**COMMENTS OF THE WESTON PLACE CONDOMINIUM ASSOCIATION
ON THE PROPOSED DEVELOPMENT AT 617 N SEGOE ROAD**

DECEMBER 5, 2013

Weston Place Condominium is located at 625 N. Segoe Road (corner of Segoe Road and Frey Street) in Madison. The Weston Place Condominium Association (Weston Place), which is the governing body for our facility, offers the following comments regarding the proposed development at 617 N. Segoe Road, a property contiguous to ours.

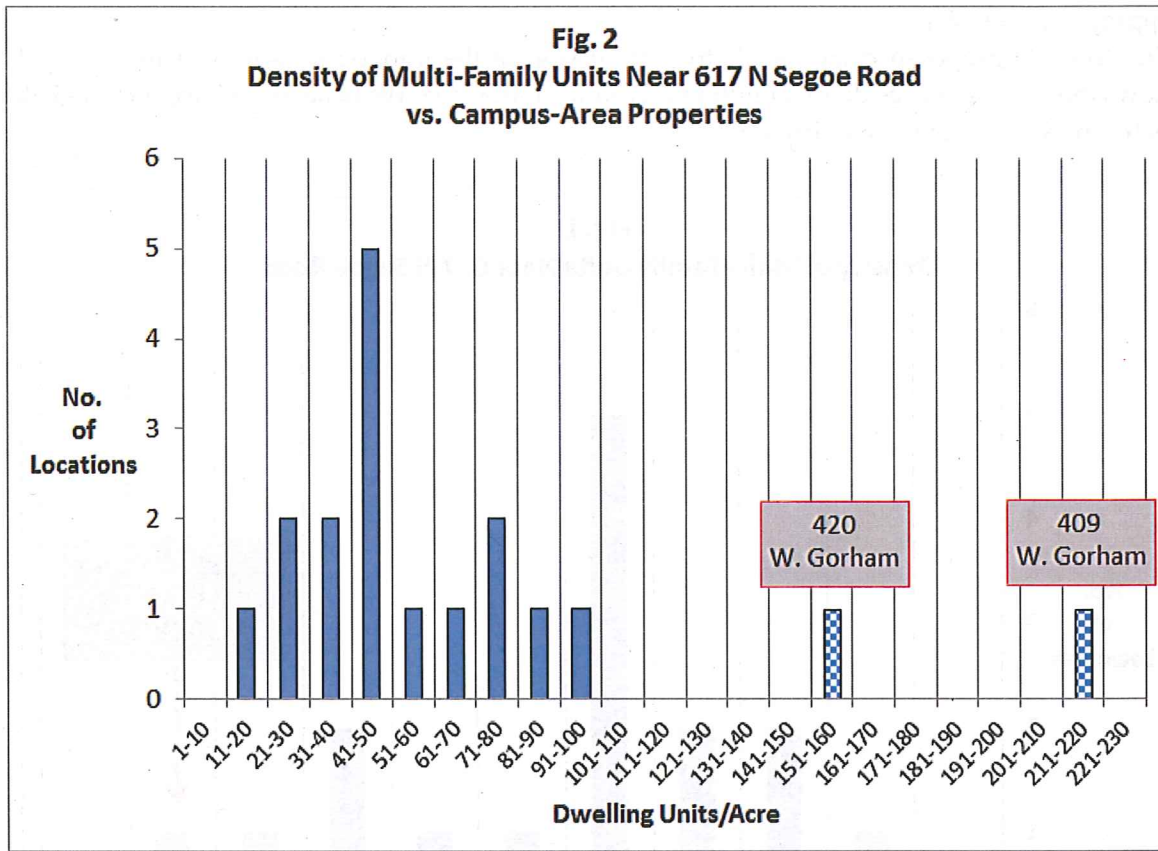
Mr. Stopple's proposed design leads to a discussion of the important issue of density. Fig. 1 shows the density for residential multi-family units in the area. We believe we have included all such complexes in the immediate area.

The figure reveals that Weston Place has the highest density of the 16 multi-family locations in the area. That said, we note that there are several other buildings with density close to that of Weston Place.

They key point is that our neighborhood densities, even that of Weston Place, are a mere fraction of the density one finds for typical student housing closer to campus. We see that by adding to the chart two multi-family near-campus developments (shown in checkerboard) that are either owned or operated by Mr. Stopple or his firm. See Fig. 2. As we will see in a moment, in terms of density Mr. Stopple's experience with those buildings appears to be his reference point for his proposed development at 617 N. Segoe Road.

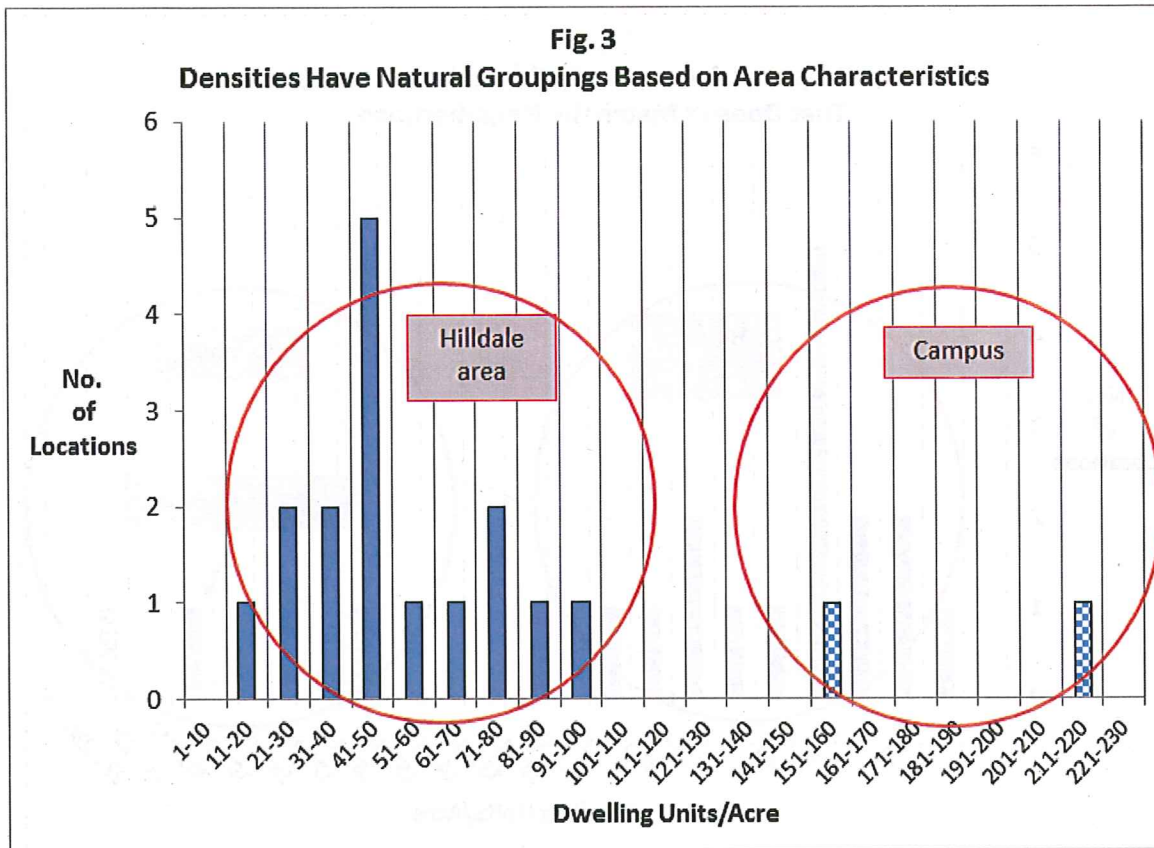
Under neighborhood-focused urban design, the density of a multi-family building at 617 N. Segoe Road should fit into the Hilldale area mold, and not that of buildings closer to campus. Contrary to these expectations, the proposal for the 617 N Segoe site lands in the wrong region in this regard. See Fig. 4.

These images speak loudly to the significance of the problem with the density of the building proposed building for the 617 N. Segoe site. **It would have about four times the density of the typical multi-family building in our area, and more than twice that of Weston Place.**

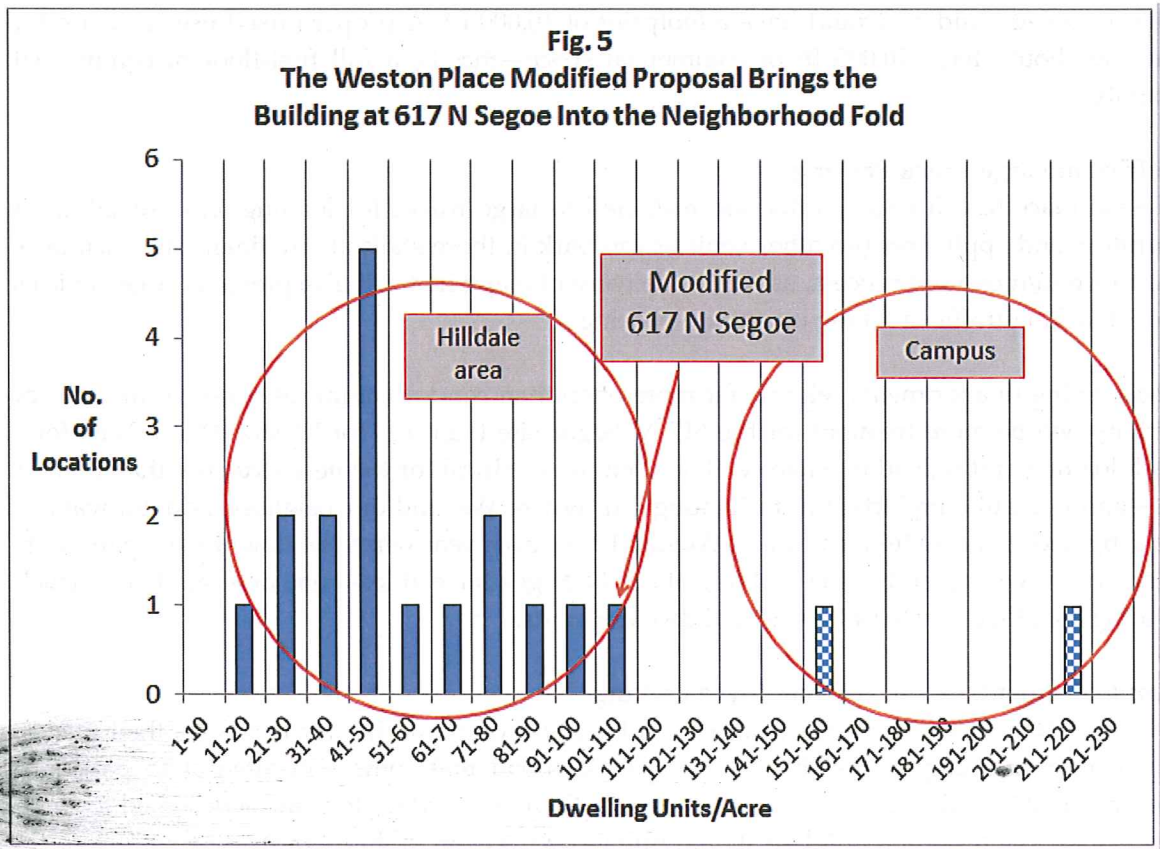
Fig. 5 shows that the modification suggested by Weston Place would put the density of the 617 N. Segoe Road site at least within close proximity to that of the neighborhood. The key is that the building would look like a Hilldale-area development, not one that belongs on campus.

We suggest that Mr. Stopple’s proposal should be modified to bring the structure closer to the neighborhood density characteristics. As noted earlier, Weston Place has the highest density in the region. We are not suggesting that Mr. Stopple’s building cannot have a higher density than Weston Place. We are suggesting that the new building should not have a density that is more than twice that of ours. As such, we suggest a compromise that moves up the bar in terms of density, but in a much more measured manner.

This result reveals just how far from reasonable the initial proposal for the site is. We suggest that the new building be allowed a significant increase—15 percent—in density relative to that of the building in the area that currently has the highest density. Even with that reasonable accommodation, Mr. Stopple would have to reduce the number of units to about half the number he is currently proposing.
